SUBJECT: PLANS AND PROPOSAL ADDENDUMS
PROJECT: STP 2023 (675)MM CONTROL: 1433-02-044
COUNTY: COMAL
LETTING: 05/04/2023
REFERENCE NO: 0419

PROPOSAL ADDENDUMS

DESCRIPTION OF ABOVE CHANGES
(INCLUDING PLANS SHEET CHANGES)

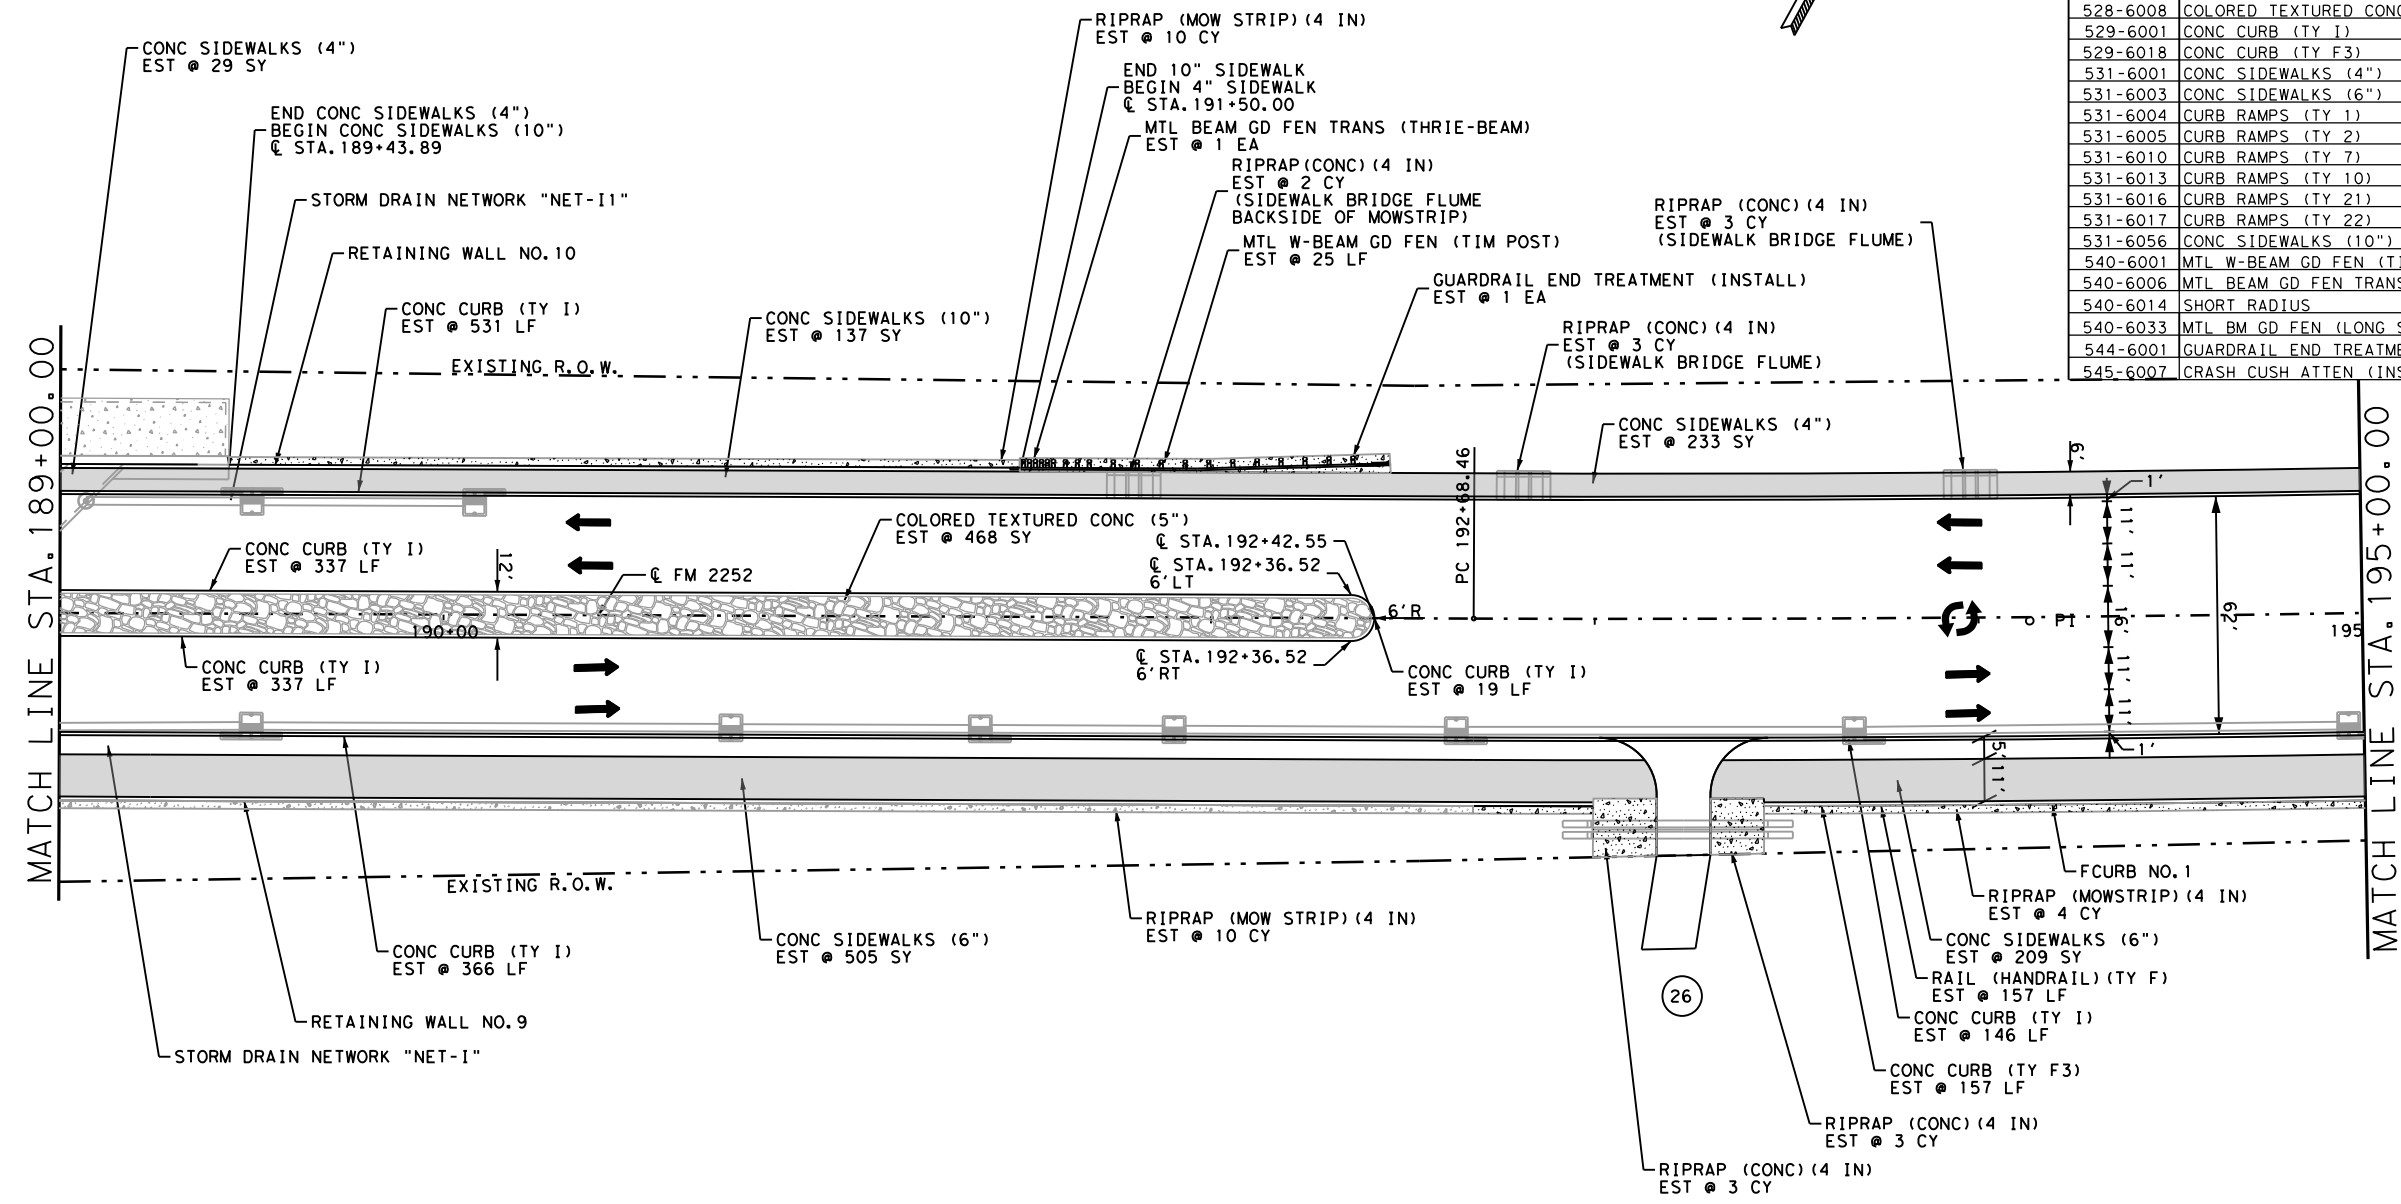
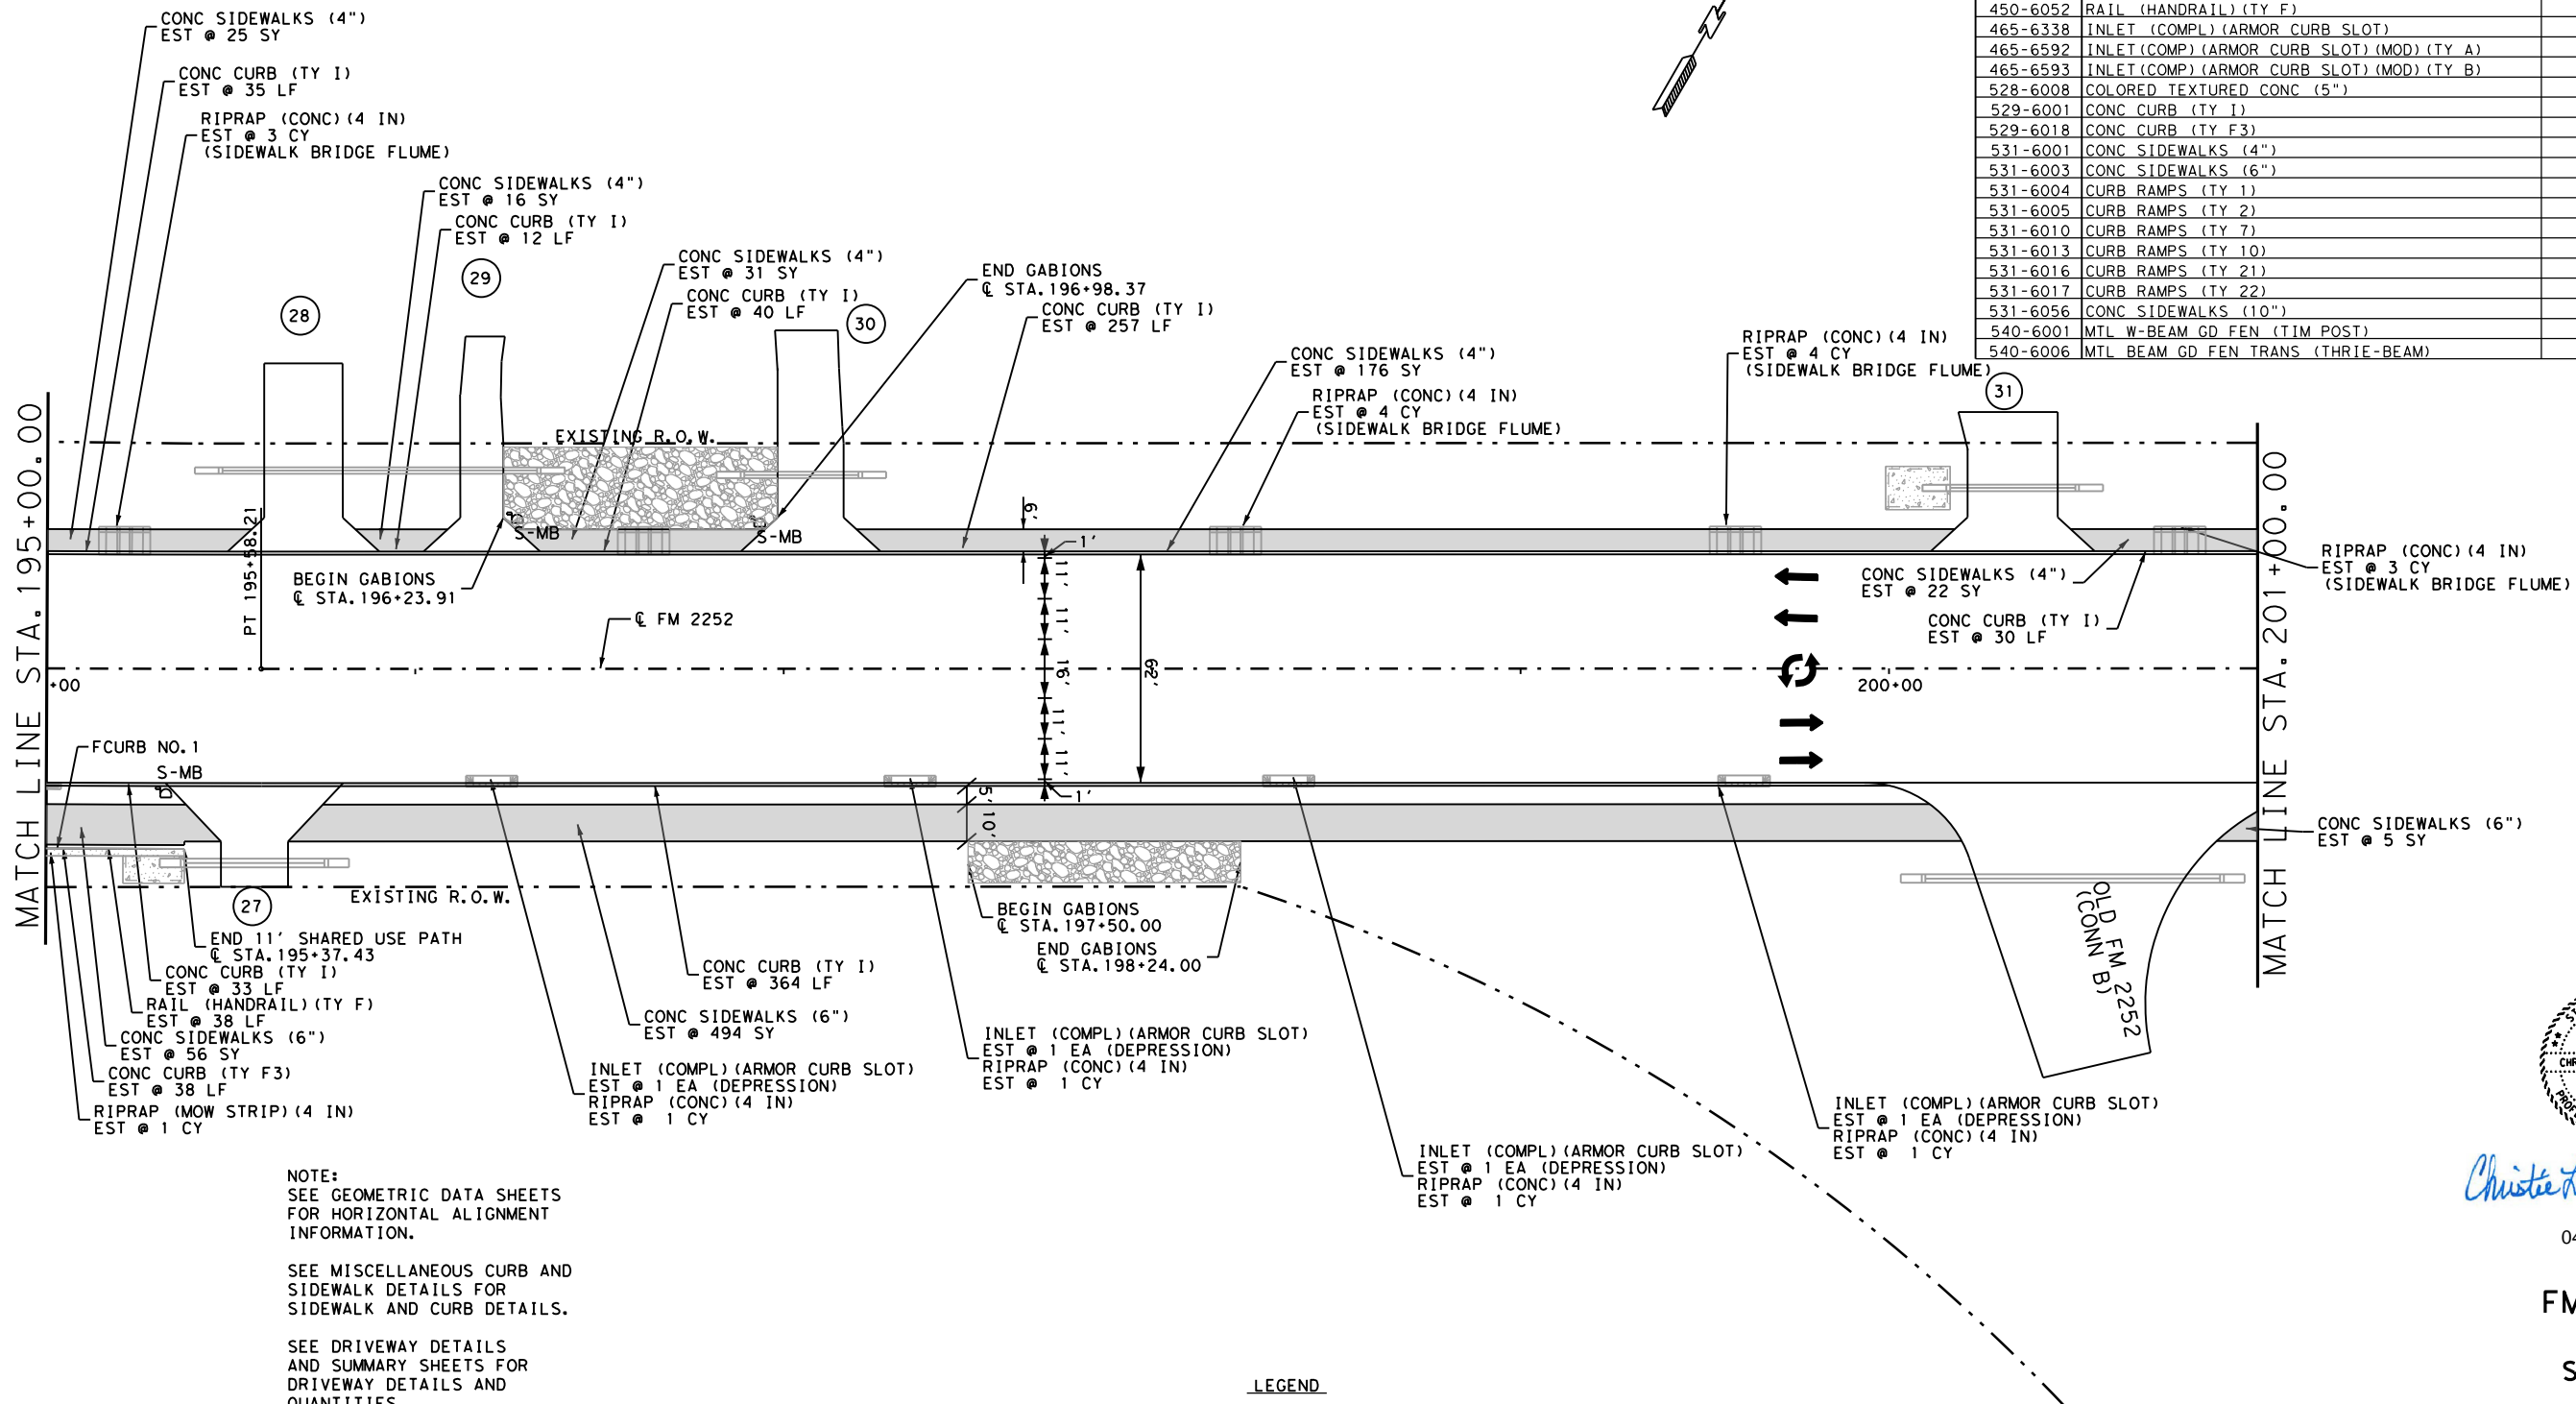
SHEETS 413-449: REPLACED ITEM NO. 545-6017 WITH ITEM NO. 545-6007
